TOWNSHIP of HOPEWELL MERCER COUNTY

To: Hopewell Township Planning Board
From: Francis J. Banisch III, PP/AICP
Date: January 21, 2025
Re: Preliminary and Final Major Subdivision and Site Plan
Venue at Hopewell
Block 93; Lots 19, 20, 45.01, and portion of 60 (Scotch Road and Nursery Road)
IMF-C Zone

RE: Block 93 Lot 19, 20, 45.01, 46, & p/o 60 **US Home (The Venue)**
Work Address: 61 & 137 Nursery Road, Scotch Road, Nursery Road
Zoning District: IMF-C
Application Type: Major Subdivision - Preliminary & Final Site Plan

RE: Block 93 Lot 19, 20, 45.01, 46 & p/o 60 **US Home Corp (The Venue)**
61 NURSERY RD., SCOTCH RD., NURSERY RD., NURSERY RD., 137
NURSERY RD.

The Venue - Western Connector - Road 6 to Brookside Drive

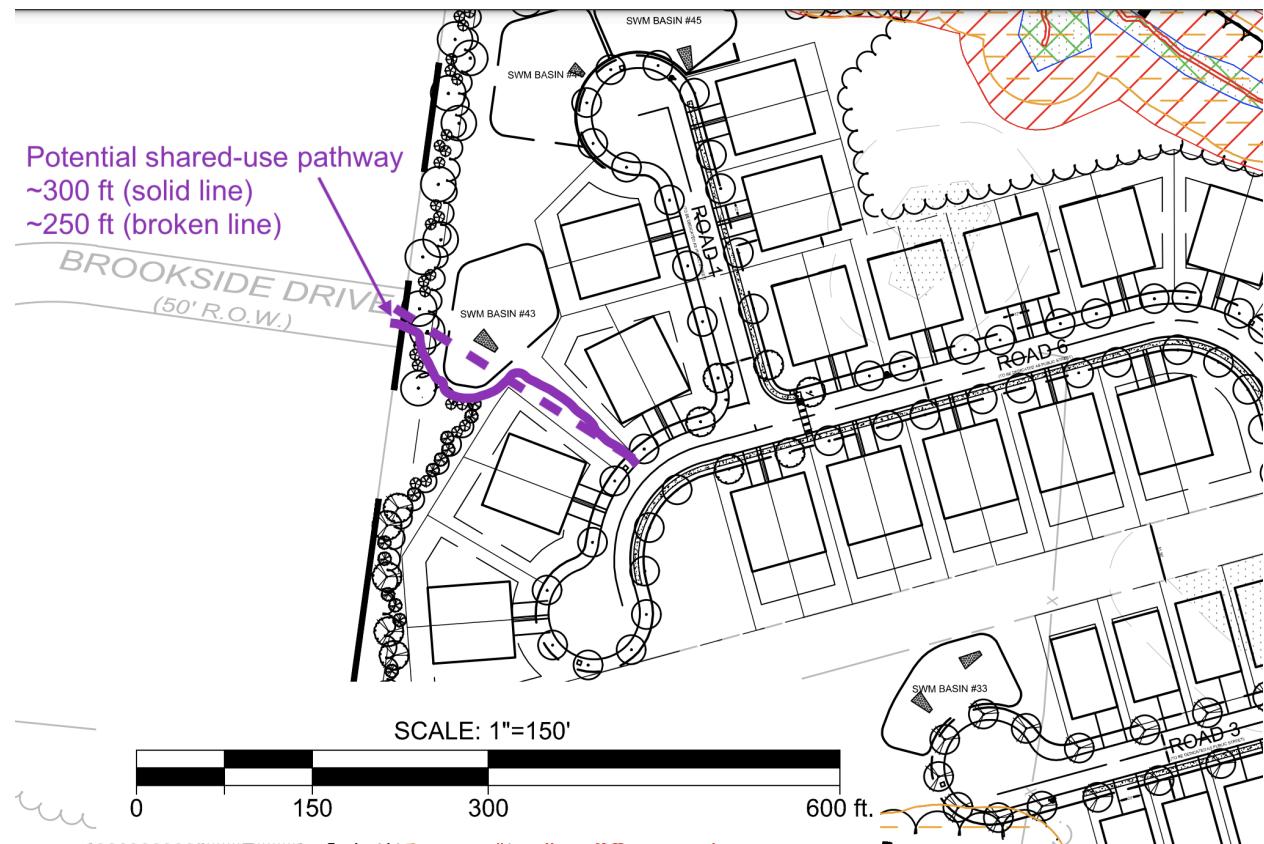
The western connector joins Road 6 in The Venue development with the stub road Brookside Drive in the Jacobs Creek neighborhood. If the shape of SWM Basin #43 were adjusted to permit a straight path between the two streets, this connector could be shortened from approximately 300 to 250 feet (broken line).

The Venue - Northern Connector - Road A to John Vanzandt Dr

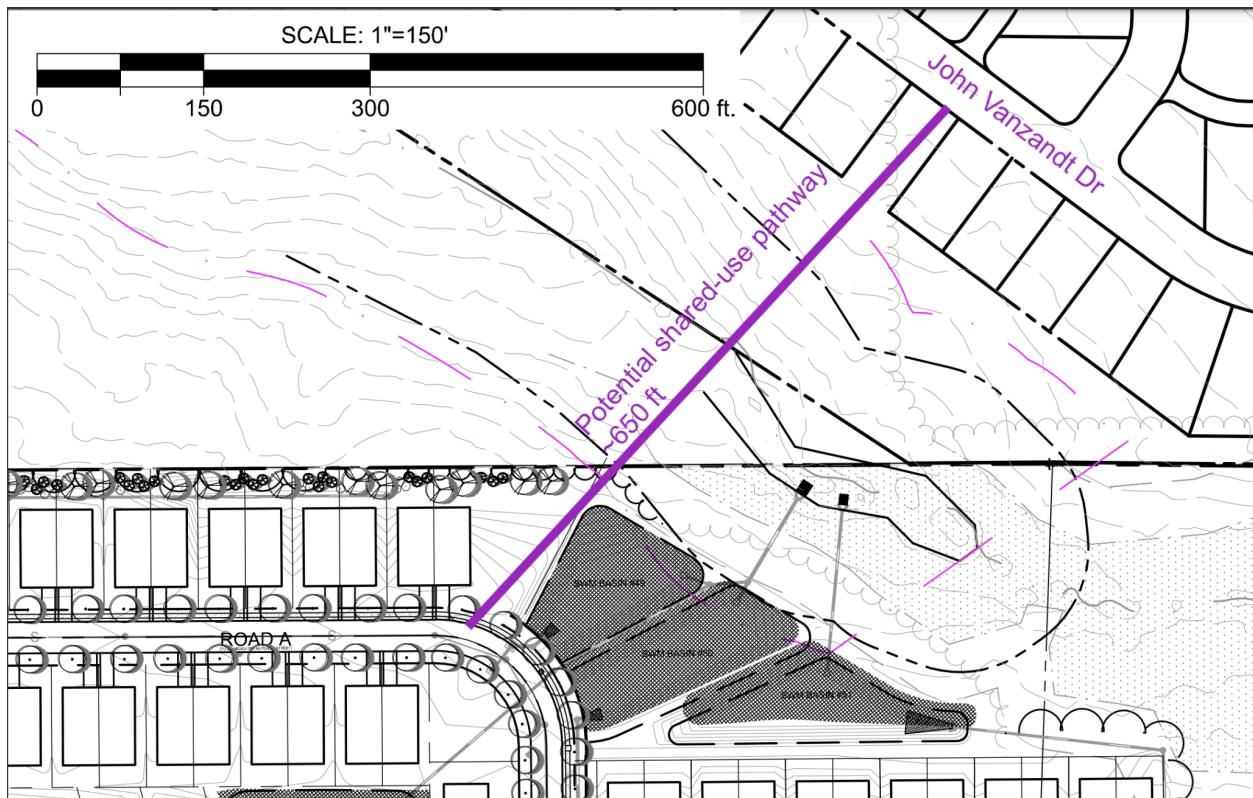
The northern connector (see below) joins Road A in The Venue development with John Vanzandt Drive in Lennar's own development, Hopewell Parc. The EC notes that the pathway appears to cross an NJDEP-designated wetland, in which case General Permit 17 or 17A would be required. These permits require that the total area disturbed be under one-quarter (0.25) acre. An 8-foot-wide pathway that is 650 feet in length would cover an area of 5,200 sq. ft. or 0.12 acre. Furthermore, only a portion of the pathway shown below would be within the NJDEP-designated wetlands area.
